Access Compliance Report

Public Rights-of-Way

(Curb Ramps)

Intersection ID: 44929	Main Street: TWIN_BROOK_DR	Cross Street: NATHAN_DR	Location:	N
ADA ID: E3290FDFBDB0	Ramp Type: Perp	Initial Pass/Fail: Pass	Overall Compliance: No	Severity Score: 0
Codes/Mitigation Info/Possible Solution		Field Measurements/Component Compliance

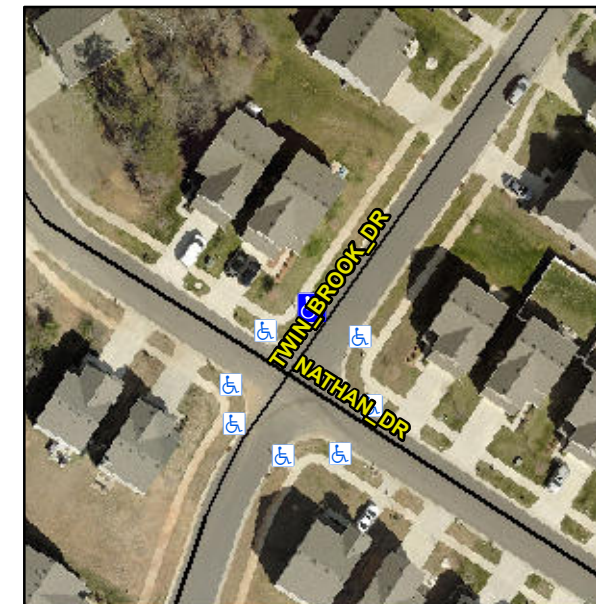
Possible Solutions:

Remove & Replace Entire Ramp.

PROW/ADA:

R304.2.2-Perp, R304.3.2-Para, R305.2
